Access Compliance Report Public Rights-of-Way (Curb Ramps)

Intersection ID: 29381 Main Street: GLENDYNE_DR Cross Street: PLEASANT_DALE_DR Location: SW

ADA ID: C067BE9302B0 Ramp Type: PerpDiag Initial Pass/Fail: Fail Overall Compliance: No Severity Score: 8.75

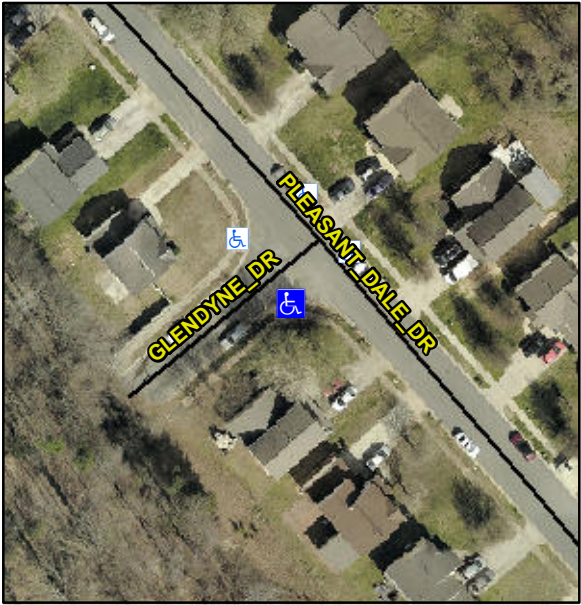
Compliance	Description	Data	Compliance	Description	Data
N/A	Ramp Length (in)	46.5	Yes	Ramp Slope (%)	7.3
No	Ramp Width (in)	39.0	Yes	Ramp XSlope (%)	0.1
N/A	Flare Type LT	N/A	N/A	Flare Type RT	N/A
N/A	Flare Slope LT (%)	N/A	N/A	Flare Slope RT (%)	N/A
N/A	Flare Traversable LT?	N/A	N/A	Flare Traversable RT?	N/A
N/A	Landing Length (in)	N/A	N/A	DWS Provided?	N/A
N/A	Landing Width (in)	N/A	N/A	DWS Contrast?	N/A
N/A	Landing Slope (%)	N/A	N/A	DWS Length (in)	N/A
N/A	Landing X Slope (%)	N/A	N/A	DWS Full Width?	N/A
N/A	Landing Curb? (Y/N)	N/A	N/A	DWS Offset (in)	N/A
N/A	Shared Landing?	N/A			
N/A	Gutter Ponding?	N/A	N/A	Gutter Slope (%)	N/A
N/A	Gutter Lip Ht (in)	N/A	N/A	Gutter X Slope (%)	N/A
N/A	Painted X Walk1?	No	N/A	Painted X Walk2?	No
	X Walk 1 Direction	To NE		X Walk 2 Direction	To NW
N/A	X Walk 1 Width (in)	N/A	N/A	X Walk 2 Width (in)	N/A
	X Walk 1 Slope (%)	0.0		X Walk 2 Slope (%)	0.4
	X Walk 1 X Slope (%)	1.7		X Walk 2 X Slope (%)	2.5

Possible Solutions:
Remove & Replace Curb Ramp With Two New Directional Ramps or Equivalent.
